Haynie Subdivision / Preliminary & Final Approval

**NAME OF PROJECT:** Haynie Density Reduction Subdivision

**AGENDA ITEM**: Preliminary/Final Approval

**Subject:** Haynie Subdivision - Preliminary / Final Approval

UTILITY PLAN

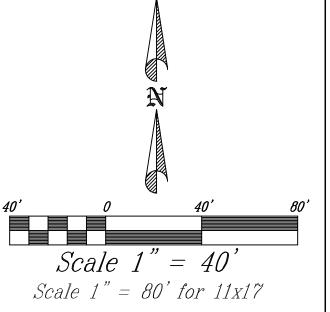
- The proposed development will be served from the Gerber Mahogany pressure zone.
- There is an existing 8" stub to the east end of the proposed development. This should be abandoned and the valve removed.

- The development must pave full width on 600 North where the asphalt is disturbed.
- There is a shared 30' driveway access off 600 North that serves all three lots.

- The proposed subdivision will need to provide an irrigation service to each lot.
- There is an existing 4" PI stub to the east end of the proposed development. This should be abandoned and the valve removed.
- A min of 4" line will need to be installed to lot three to provide adequate service.
